LUPC STAFF REPORT

Case No: DIR-2025-412-CDP-MEL-HCA

Address of Project: 807 6th Avenue

Attached is the boring log from the Geotechnical report showing the level of groundwater occurrence.

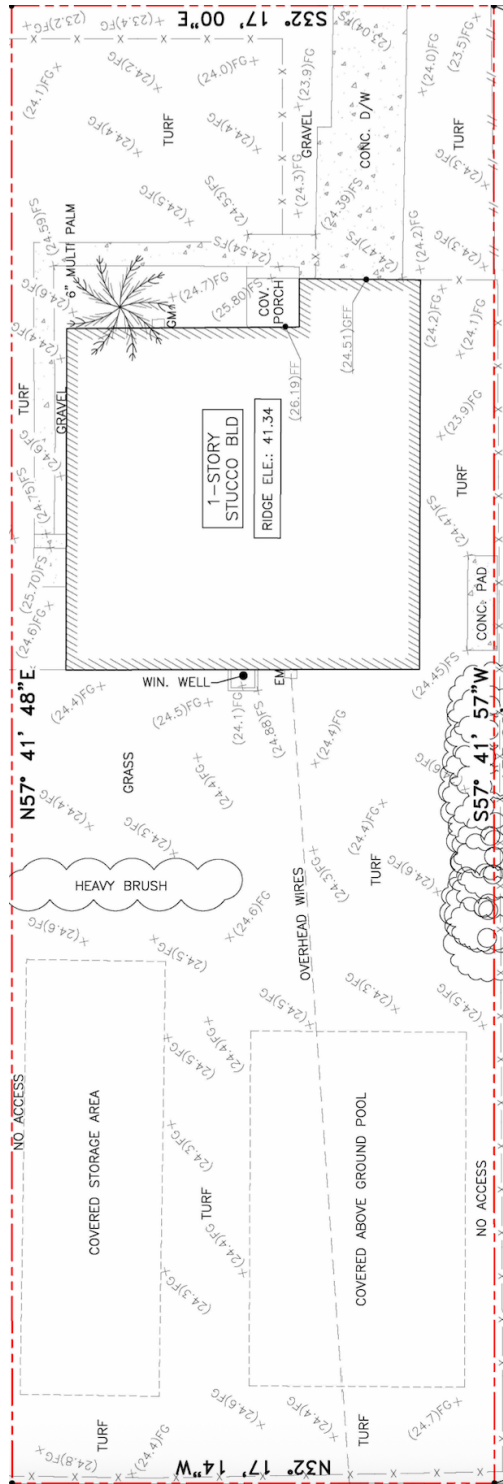
There were some questions about de-watering and the basement and the water table on the site. The applicant's representative followed up with the Geological Engineer who prepared the Geotechnical report, and he stated that since they did not hit water until 26 feet below ground surface and the proposed basement only extends 13.5 feet below the existing natural grade, that they are unlikely to hit groundwater during excavation.

Roof Plan:

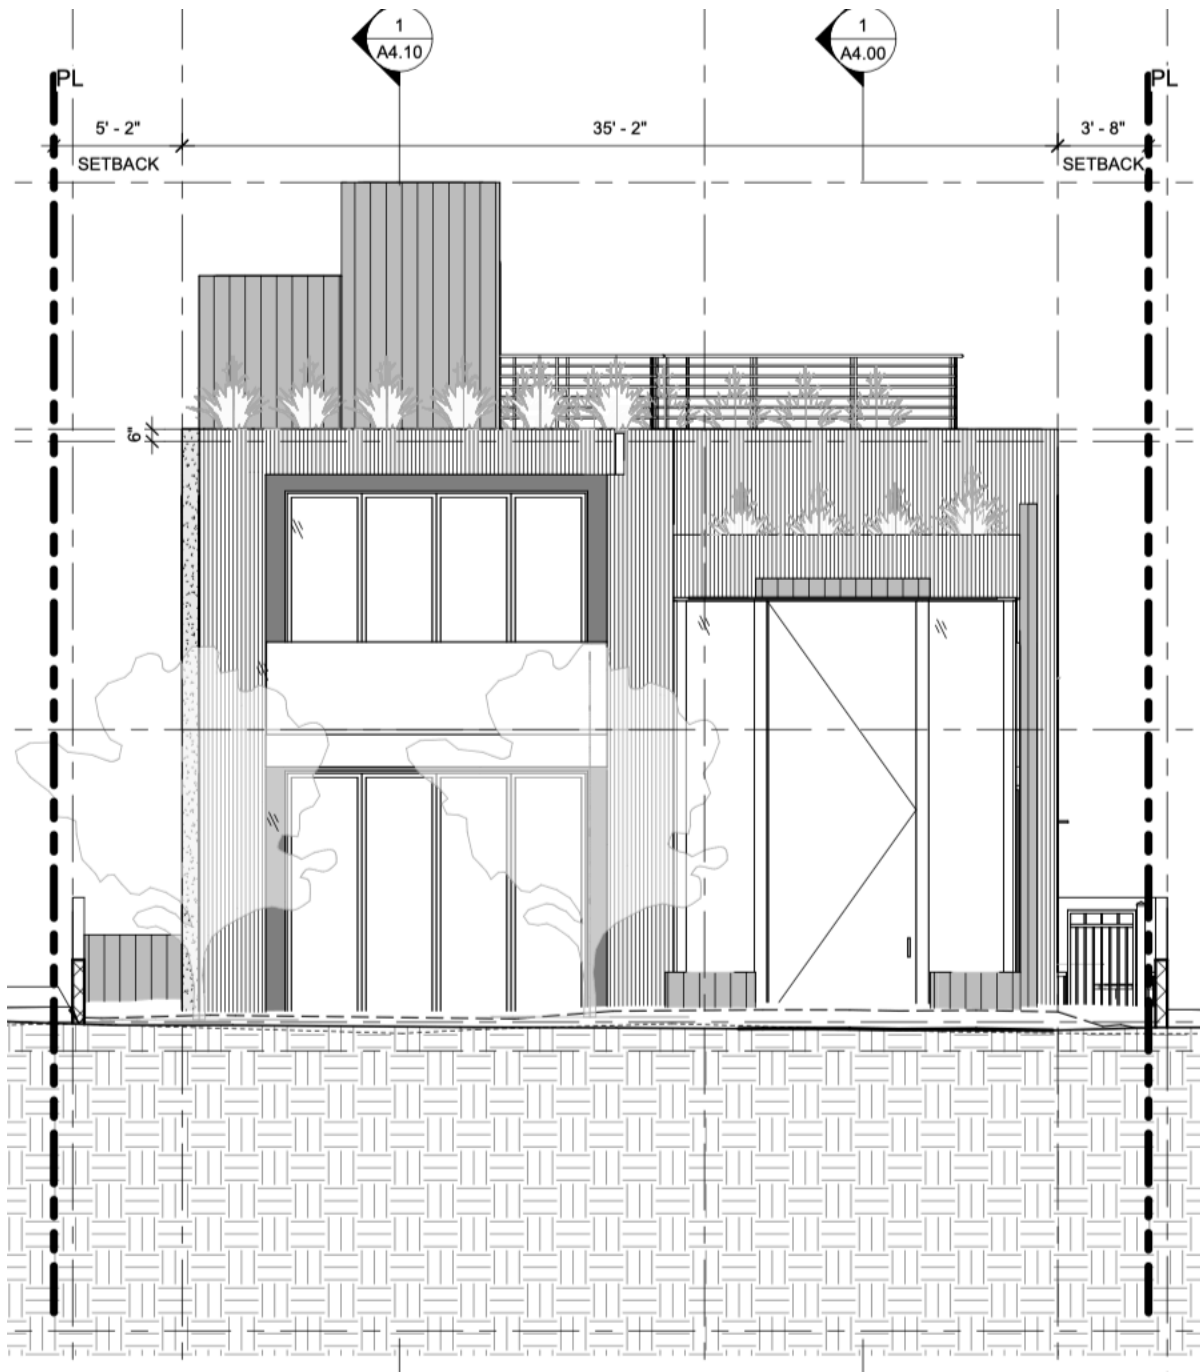
The Venice Neighborhood Council (VNC) Land Use and Planning Committee recommends that the VNC supports the City's approval of a Coastal Development Permit (CDP) for the project at 807 6th Avenue, on the following conditions: (i) elevator moves to center mass of building; (ii) elevator placement to allow use by both main home and ADU; and (iii) roof deck area is reduced by 50%.

The public and LUPC members discussed concerns about the sheer size, felt that the roof deck is way too large, indicated the elevator should be moved further to the rear of the structure as it is located towards the front (approximately 25% back from the property line) and presents as a third story and adds too much mass, and the elevator should be available for use by the ADU as well.
